**TOWN OF NEWBURGH
PLANNING BOARD
TECHNICAL REVIEW COMMENTS**

PROJECT: PET HOTEL AND DAYCARE (MIDDLEHOPE VET)
PROJECT NO.: 2012-19
PROJECT LOCATION: SECTION 9, BLOCK 3, LOT 22.1 & 23 & 22.2
REVIEW DATE: 31 MARCH 2017
MEETING DATE: 6 APRIL 2017
PROJECT REPRESENTATIVE: T.M. DEPUY ENGINEERING & LAND SURVEYING, P.C.

Re: Proposed Pet Hotel &
Day Care Facility
Section 9, Block 3,
Lots 22.2, 23 & 22.1 (P/O)
Town of Newburgh Job #2012-19

LOT LINE CHANGE AND
LAND CONSOLIDATION MAP
OF LANDS OF
**RANNE, LLC AND
RICHARD SOLOMONS**
TOWN OF NEWBURGH
ORANGE COUNTY, NEW YORK

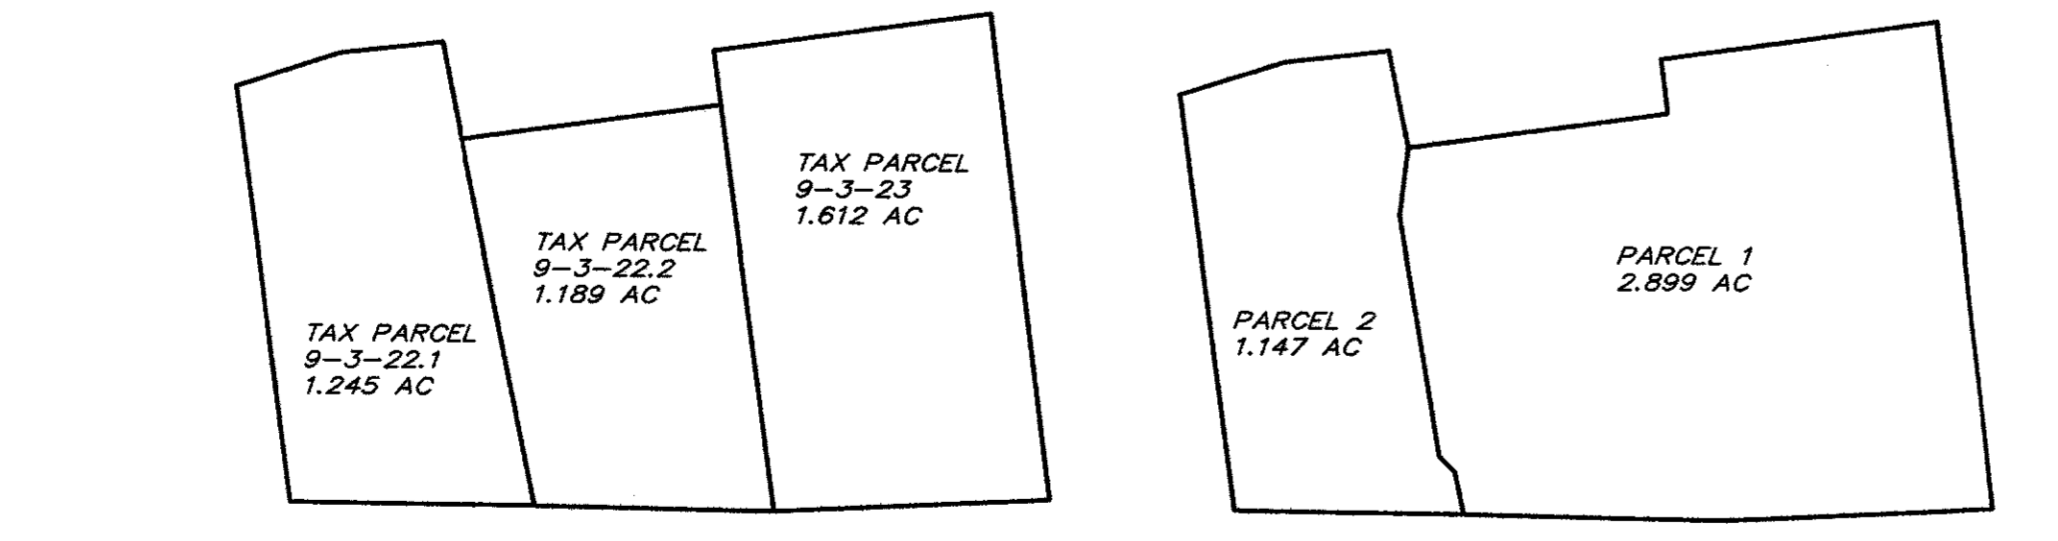
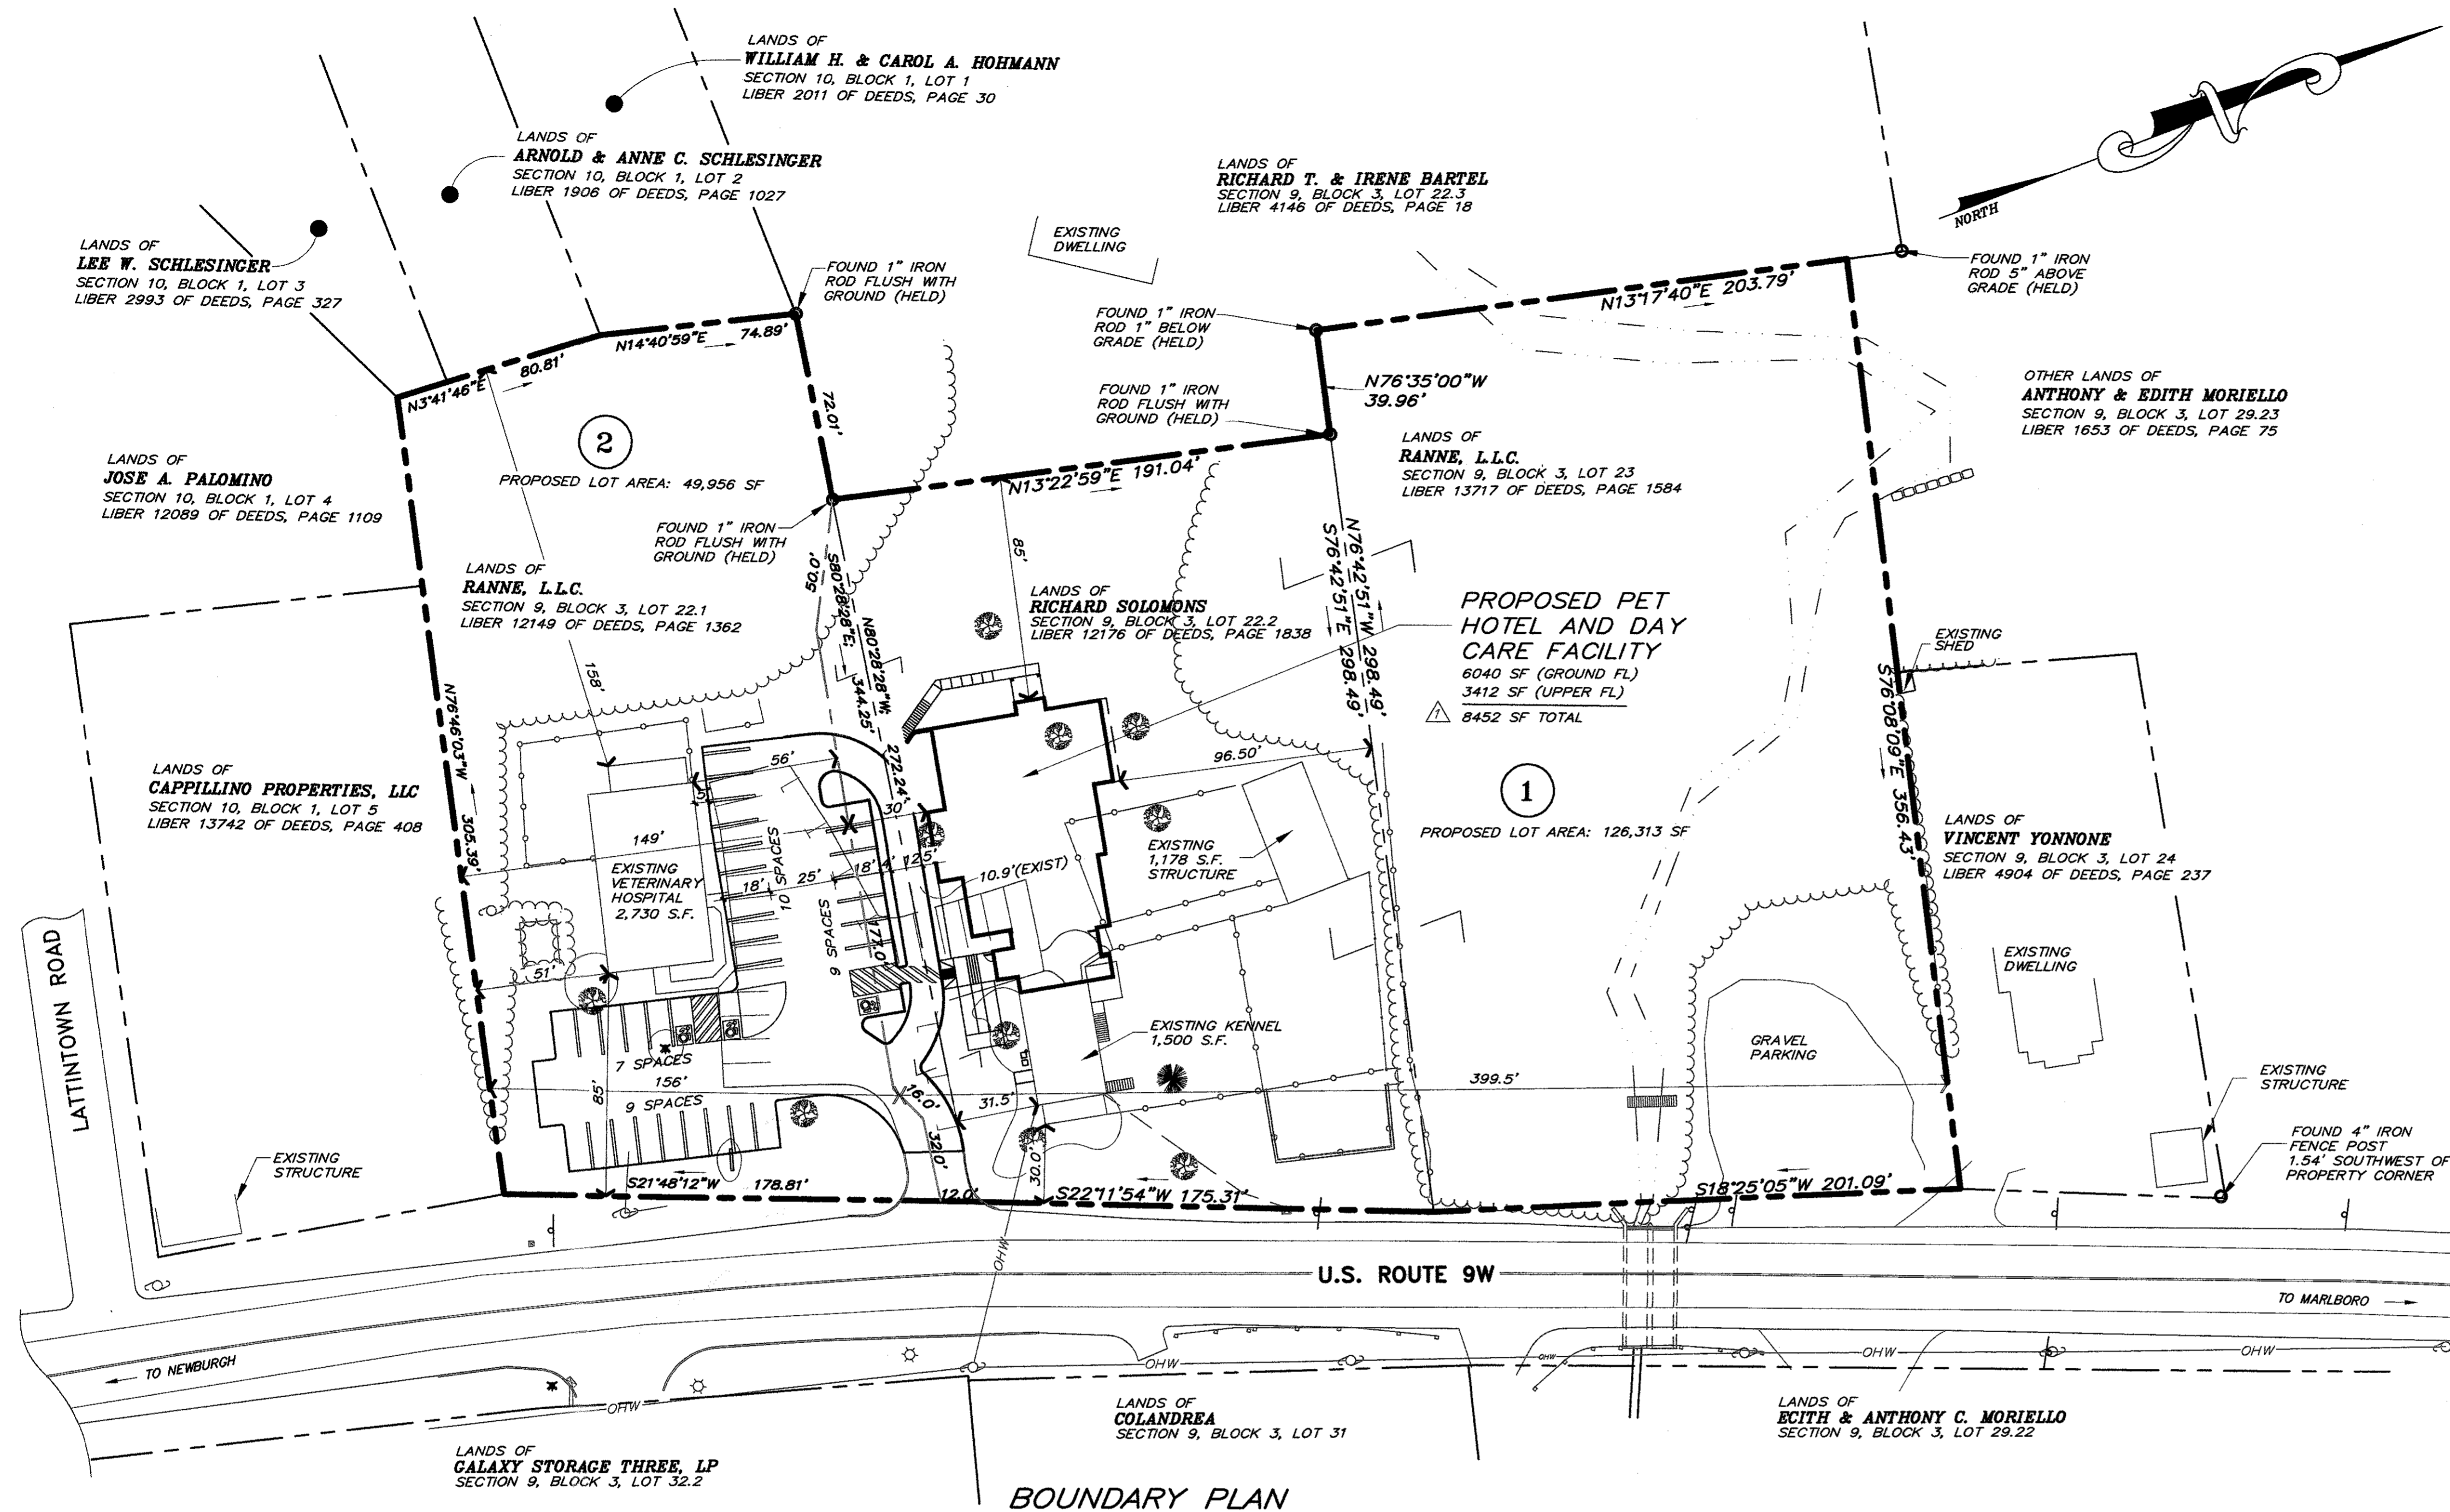
1. The transfer table on the Lot Line Change plan has been corrected to list 22.1, and the second lot has been relabeled.
2. Shared parking arrangements and unified site plan agreements are being finalized and a note concerning this has been placed on the drawing.

TITLE	SITE PLAN
JOB	12003.1
DATE	OCTOBER 2016
SCALE	AS NOTED
DWG.	SP2
SHEET	2 OF 11

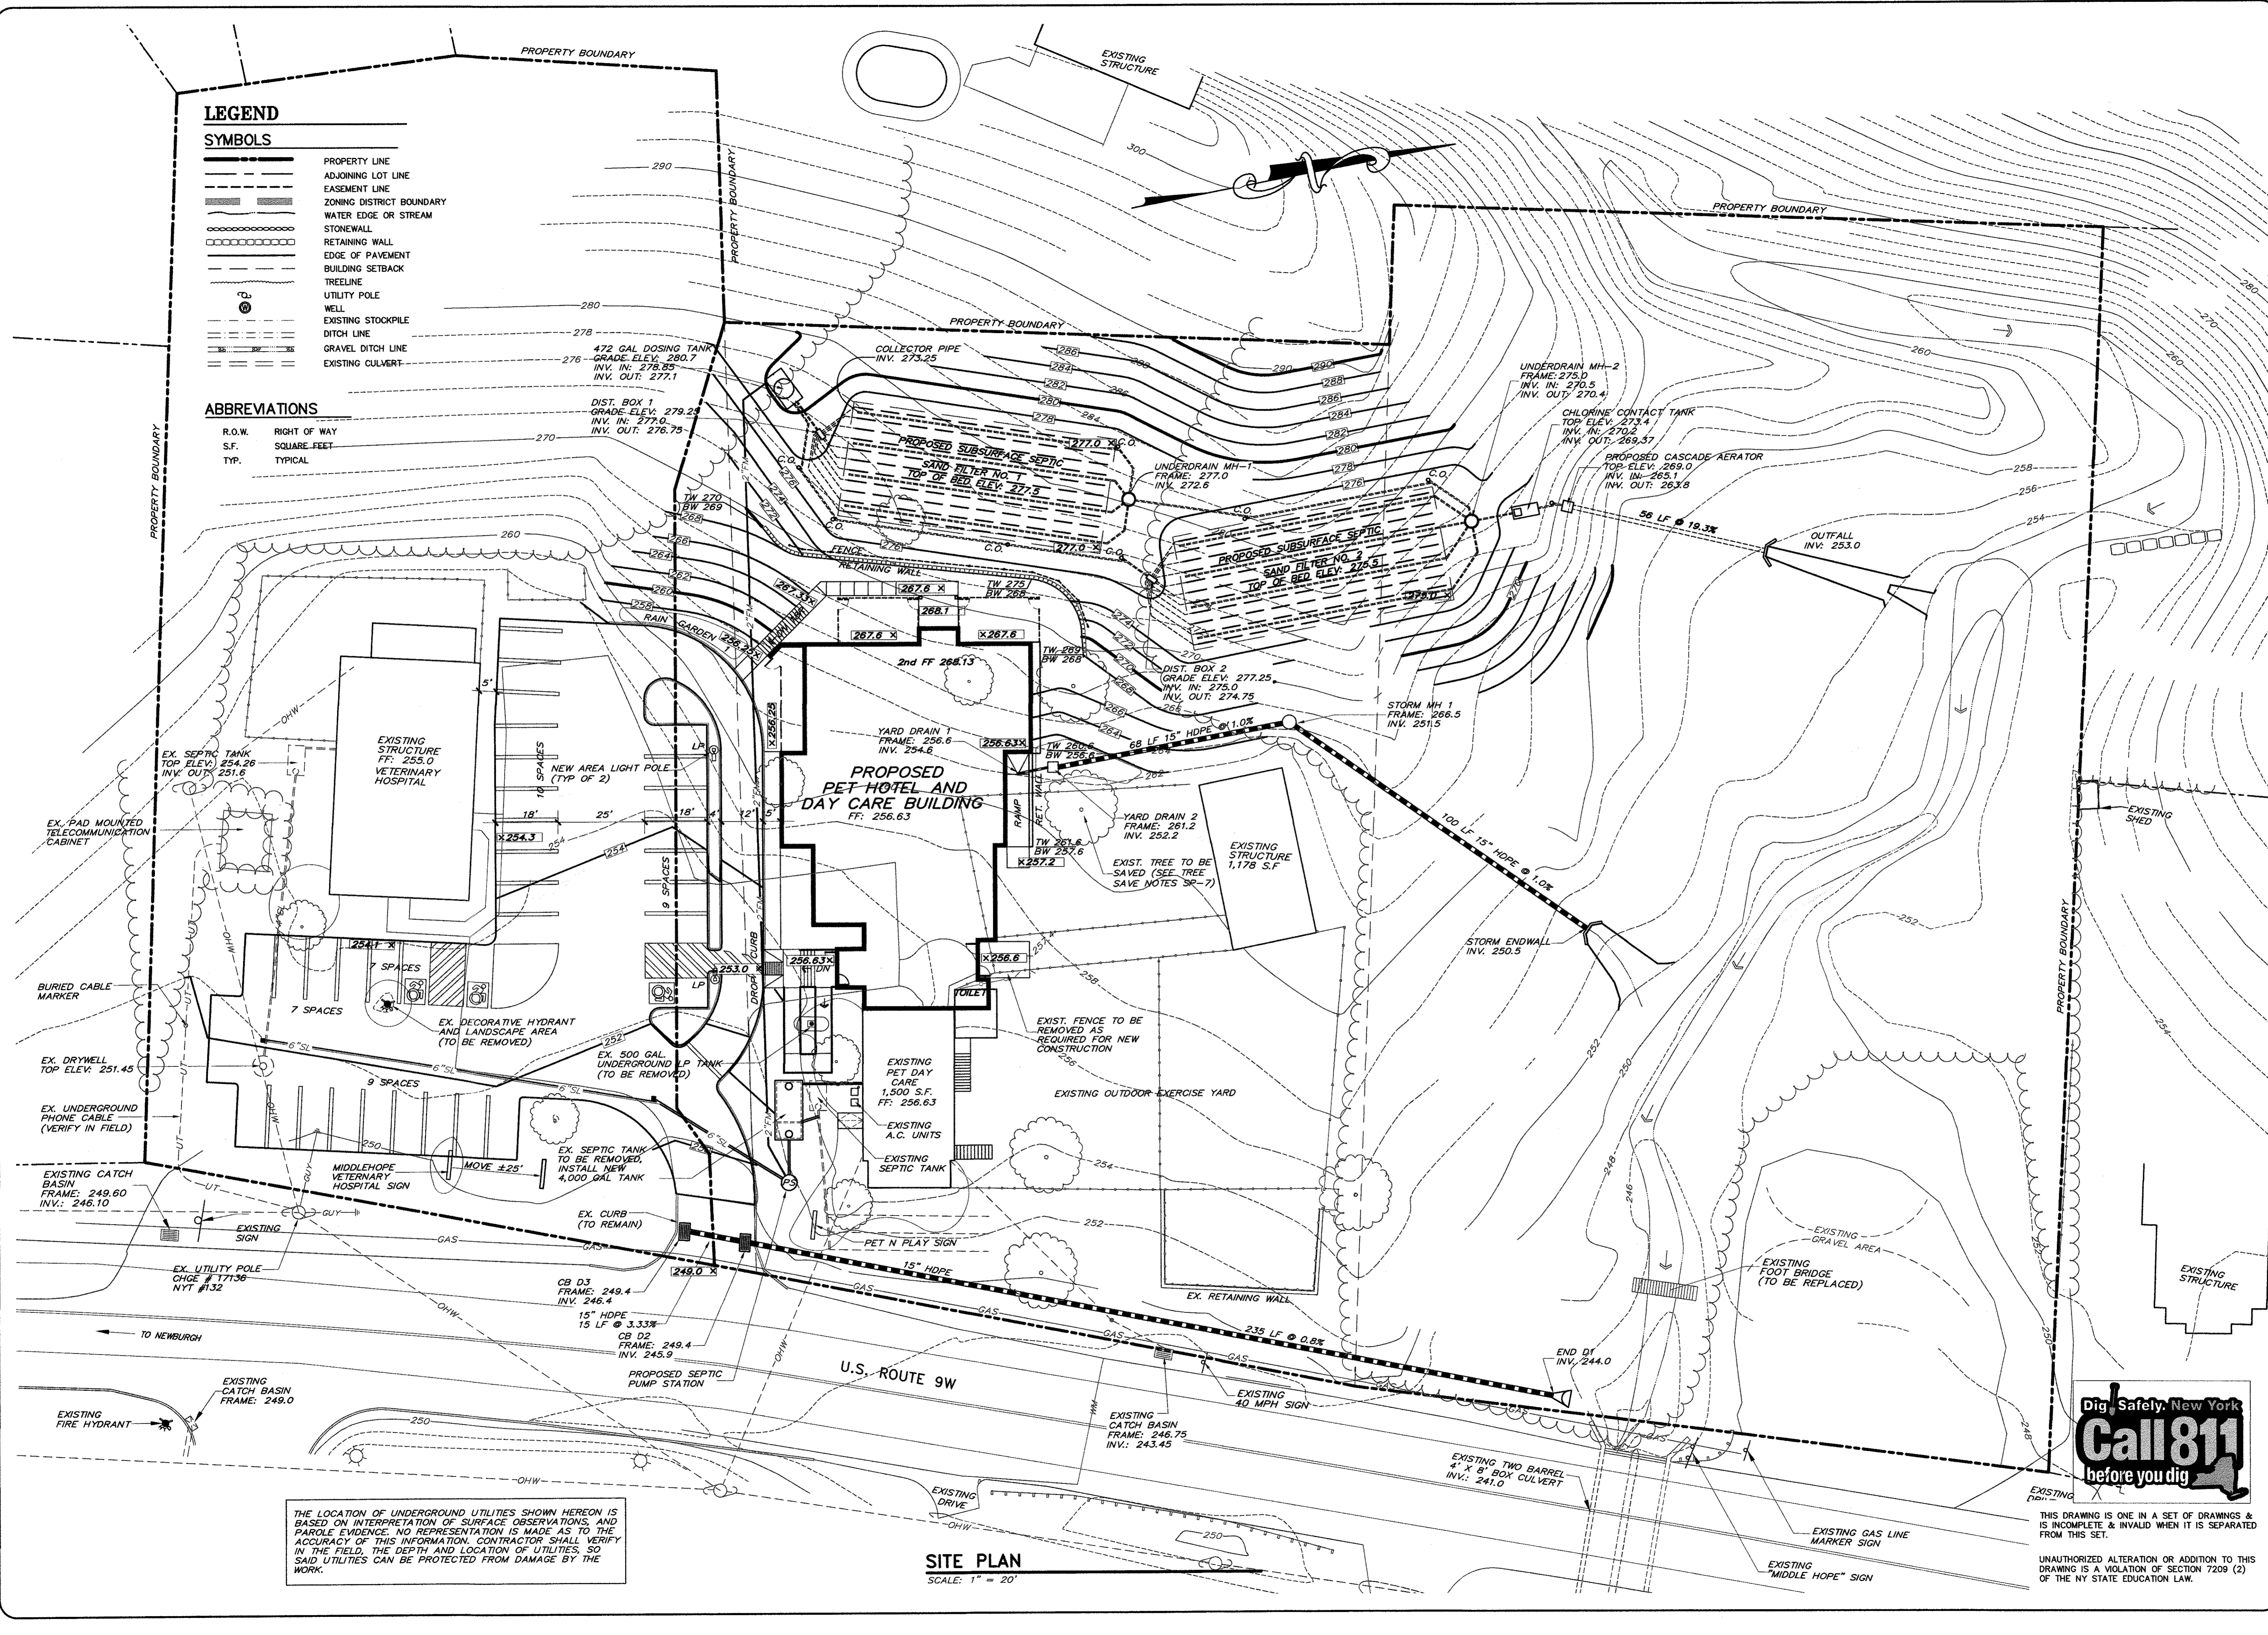
8. The parking spaces closest to the proposed Pet Hotel are labeled 9 spaces while only 8 are now provided due to the handicap accessibility.
9. Zoning data cable should be revised for number of parking spaces. Parking spaces are currently proposed at 34, including 3 accessible.

8. The parking has been slightly revised to indicate one additional handicap parking space with access way into the pet hotel and day care facility.
9. The owner's endorsement note has been removed from SP1.

E CHAIN LINK FENCE
N.T.S.

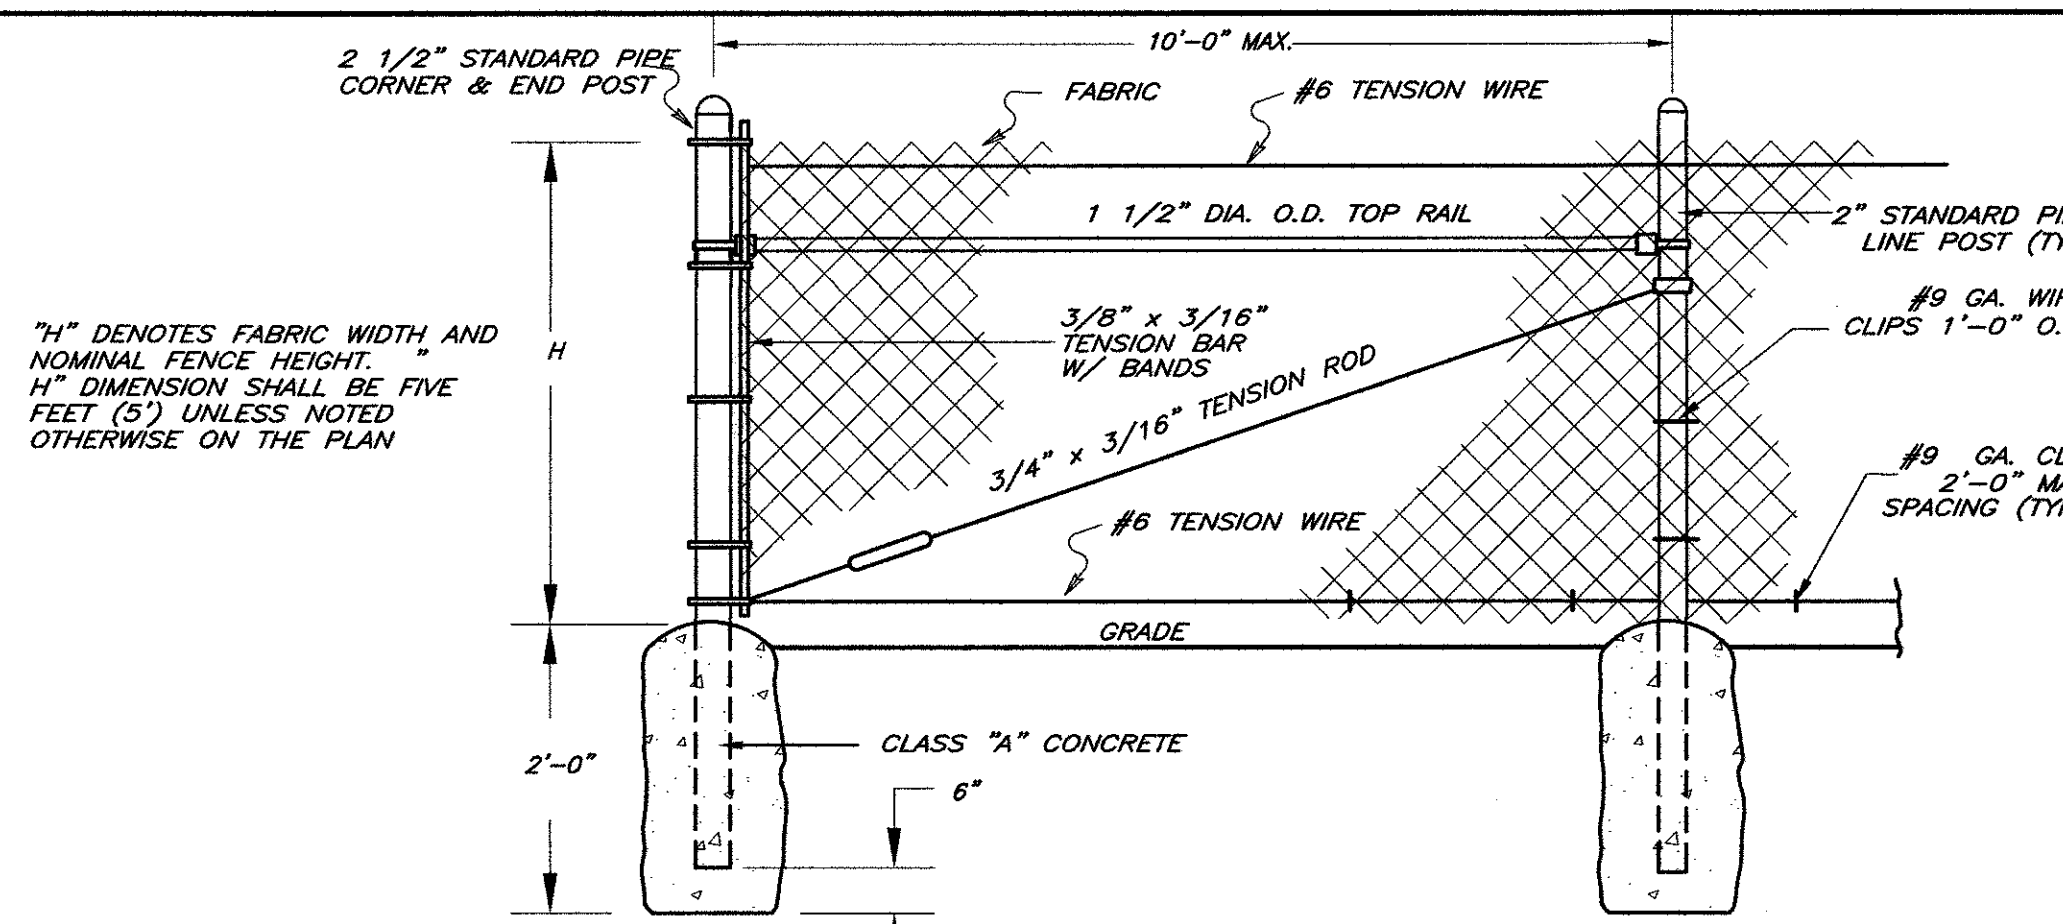
7. We would recommend that the chain link fence proposed above the retaining wall be black vinyl coated consistent with previous Planning Board approvals.
